Re: Florida Power & Light Company
Proposed Turkey Point Units 6 and 7
Docket Nos. 52-040 and 52-041
Response to NRC Request for Additional Information Letter No. 037
(eRAI 5896) SRP Section - 02.05.02 Vibratory Ground Motion

NRC RAI Letter No. PTN-RAI-LTR-037

SRP Section: 02.05.02 - Vibratory Ground Motion

NRC RAI Number: 02.05.02-2 (eRAI 5896)

Figure 14c. Caribbean 0.5Hz weighted mean attenuation curve for a magnitude 8 earthquake.

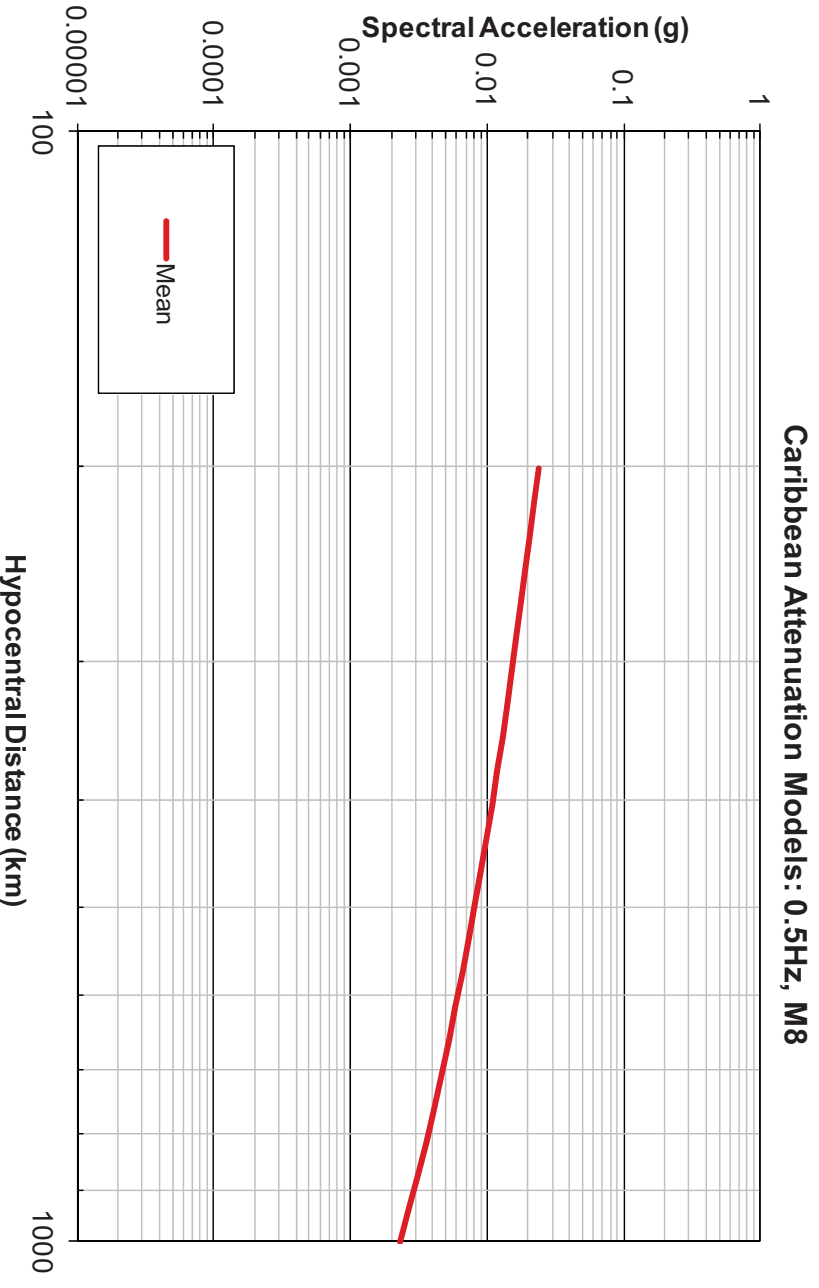
- d. In order for the staff to be able to compare the new Caribbean GMPEs with the 2004/2006 EPRI mid-continent GMPEs, please provide plots showing both ground motion models for earthquake magnitudes of 6.0, 7.0, and 8.0 in the distance range of 200 km to 1000 km at all seven frequencies defined in the EPRI 2004 and 2006 GMPEs.

Ground motion attenuation curve plots are provided for the EPRI (FSAR References 242 and 203) and Caribbean ground motion prediction equations (GMPEs). Note that EPRI (FSAR Reference 203) is only a recommendation for the associated aleatory uncertainty and therefore does not impact the comparison plots of the weighted mean ground motion

attenuation curve. The plotted mean attenuation curve is the weighted mean of the individual median attenuation curves as defined in EPRI (FSAR Reference 242). These attenuation plots are provided for three specific moment magnitude (M_w) values: 6, 7, and 8 for distances between 200 km and 1,000 km. Note that the EPRI (FSAR Reference 242) ground motion attenuation model is defined as a function of epicentral distance, whereas the Caribbean ground motion attenuation model is defined as a function of hypocentral distance. However, because the closest distance is 200 km, the difference between the epicentral and hypocentral distances would be less than 1% for a typical crustal depth of 10 km and even smaller for larger distances out to 1,000 km.

The weighted mean ground motion attenuation curves for the EPRI (FSAR Reference 242) model are given in Figures 1 through 7 for the three magnitudes and seven spectral frequencies requested in the RAI. The weighted mean Caribbean ground motion attenuation curve plots for the same suite of magnitudes, distances, and spectral frequencies are shown in Figures 8 through 14.

Figure 1. Compression Wave Velocity Profiles for Sonic Logs 0001, 0002, 0005, 0007, 0008, 0010, LAB-TW and PBF-12

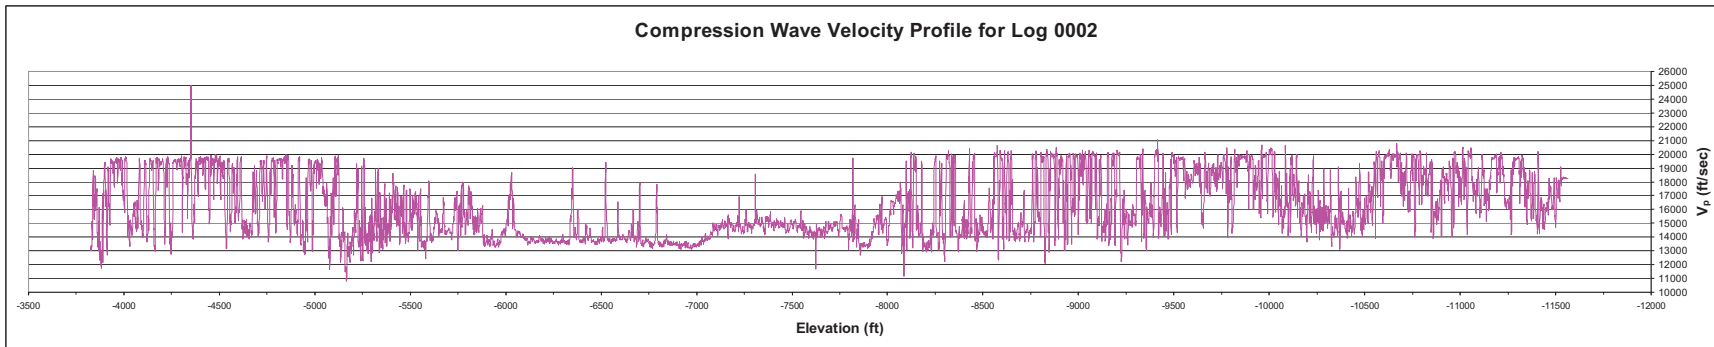
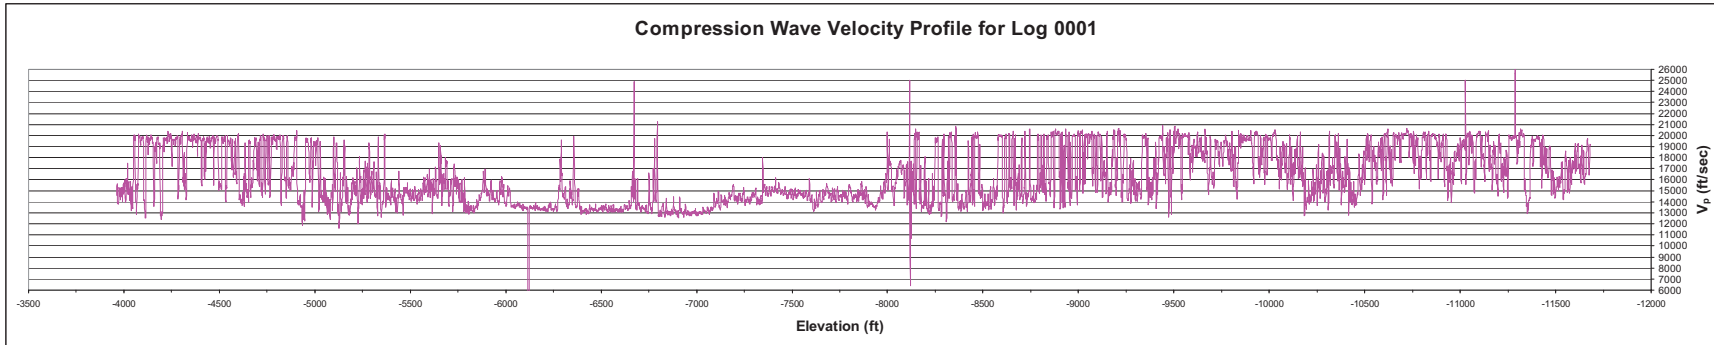
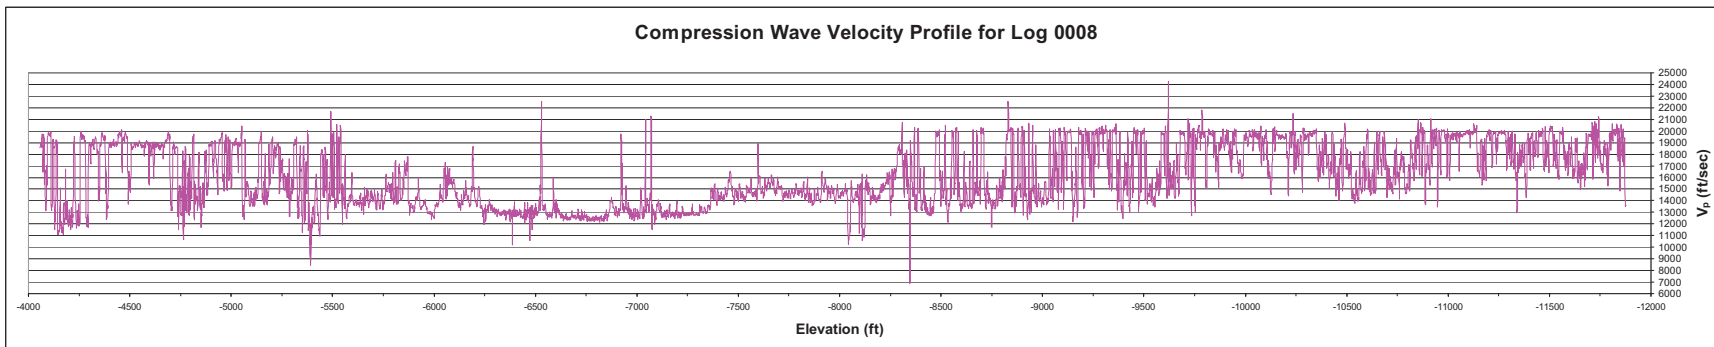
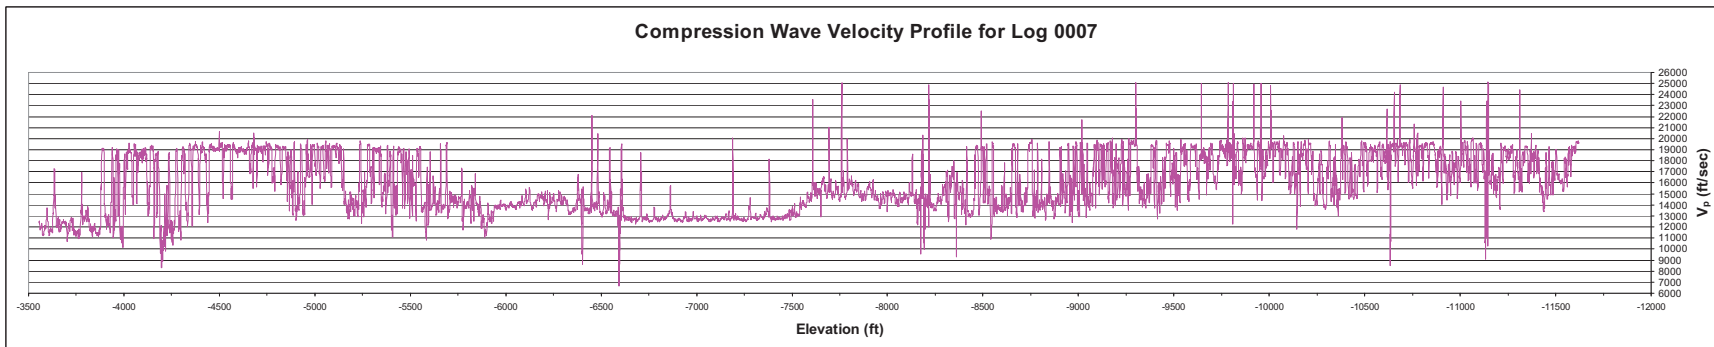
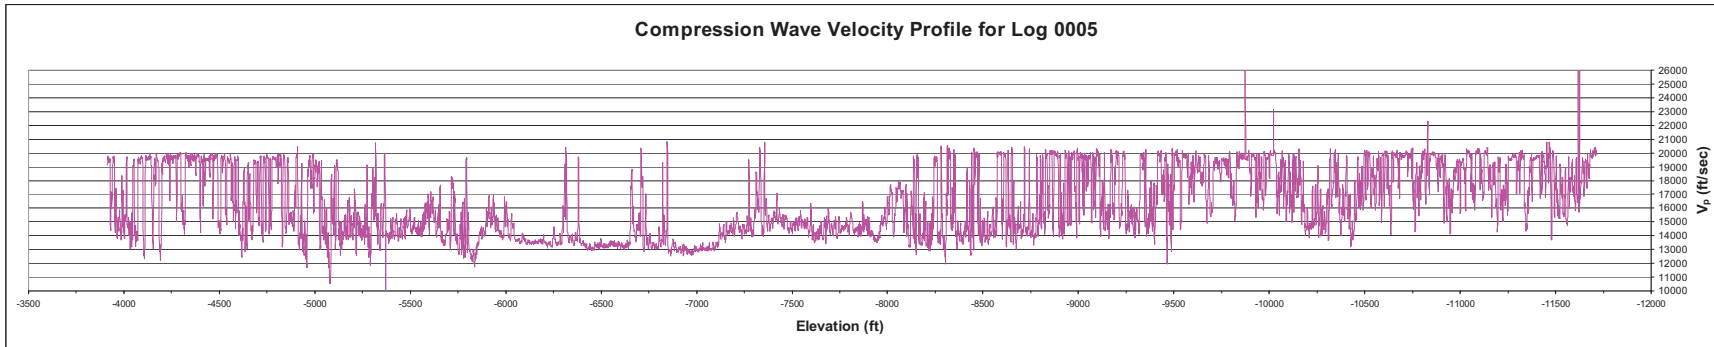
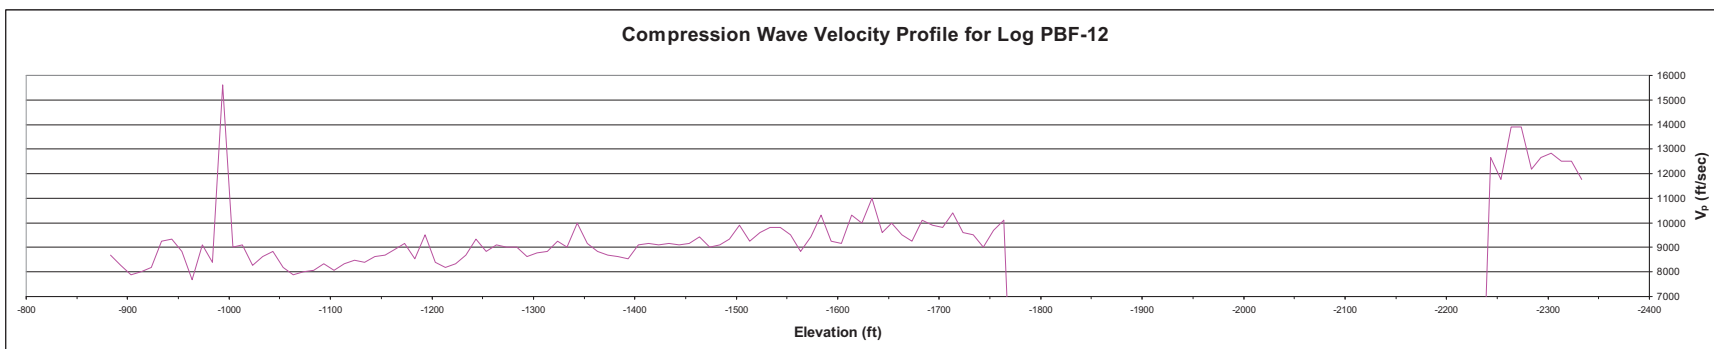
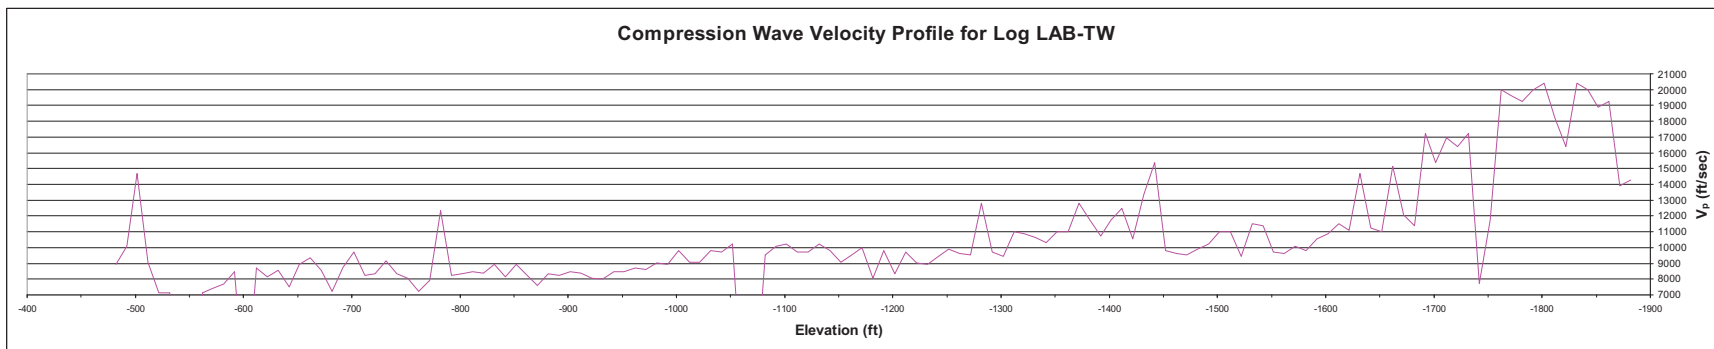
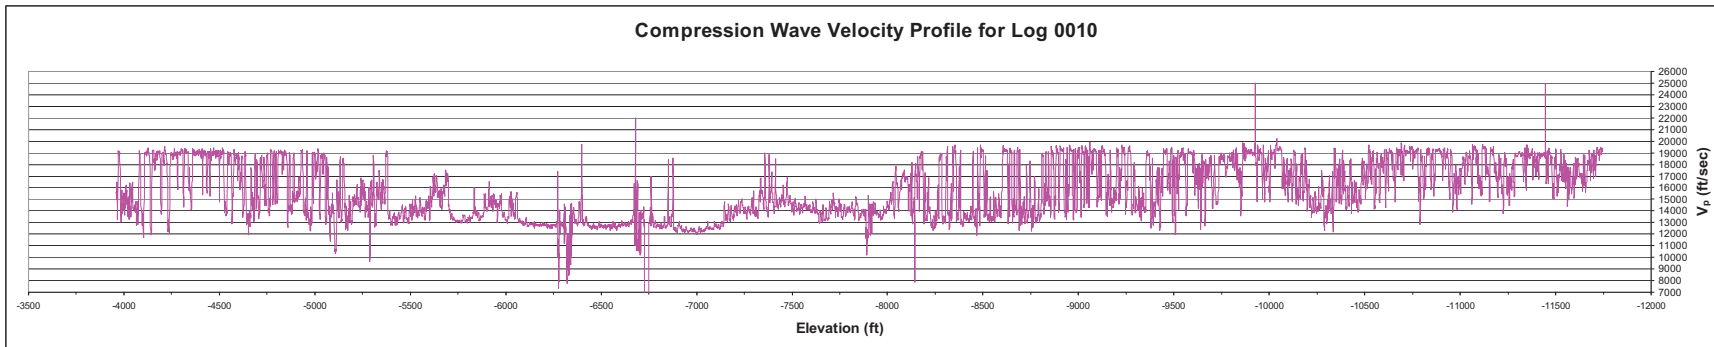
- a. additional information on the applicability of seismic velocity information obtained at such great distances to the Turkey Point site. How was the variation in geology considered in these projections?
- b. individual velocity profiles for each of the eight wells used in estimating the average profile shown in FSAR Figure 2.5.4-211
- c. further details on how larger uncertainties in deeper layers' thicknesses/depths are taken into account in the randomization of the site profile

- b) The velocity profiles for each of the 8 wells are shown in Figure 1.
- c) The uncertainties in the dynamic properties of the deeper layers were taken into account by the following two steps.
